# City of Fresno Planning and Development Department

# Conditions of Approval December 2, 2020

### Conditional Use Permit Application No. P20-02171

Conditional Use Permit Application No. P20-02171 was filed by Mehdi Momen and pertains to 0.20 acres of property. The application is a request to construct a duplex in the RS-5 (Residential, Single-Family, Medium Density) zone district.

SITE PLAN

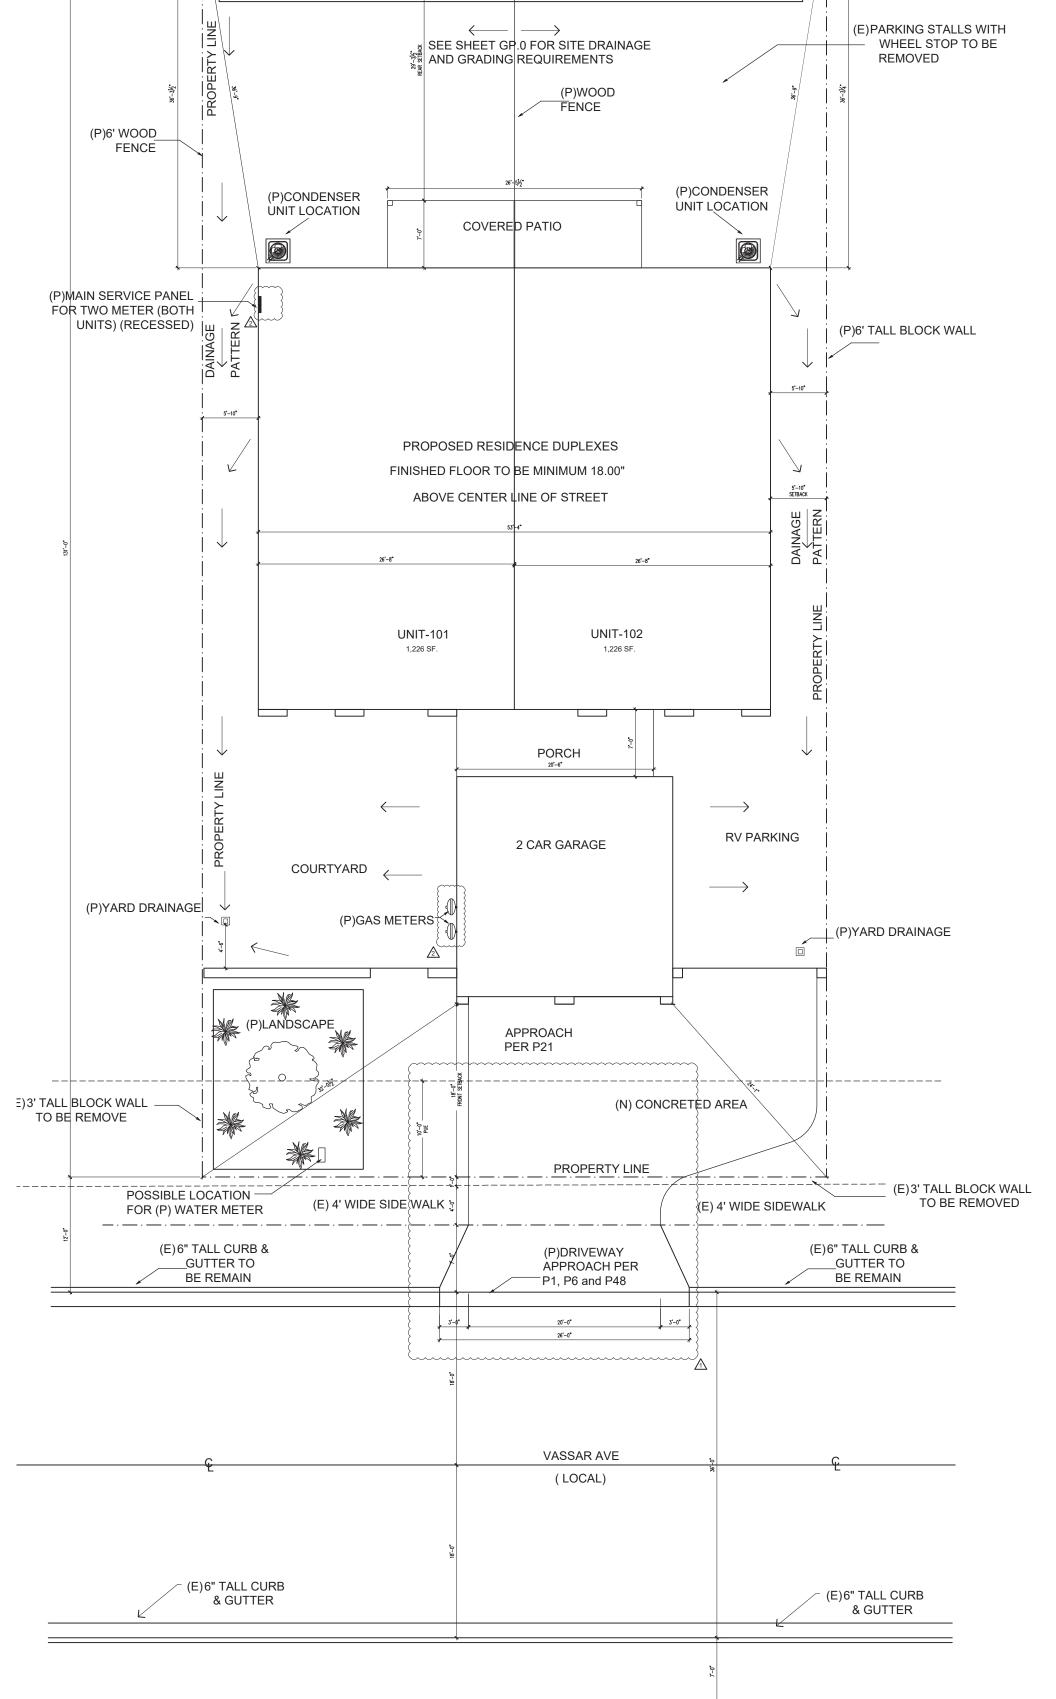
Prior to resubmitting the corrected exhibit, provide the following information and conditions of approval on the site plan:

1. <b>Property Lines:</b> Revise and dimension all existing property li	1.	operty Lines	s: Revise	and dime	ension all	existina	property	lines
---	----	--------------	-----------	----------	------------	----------	----------	-------

2. **Legal description:** Provide legal description.

The driveway required to meet *Public Works Standards (P-21) and Specifications*. Provide corrections as noted on **Exhibit "A".**
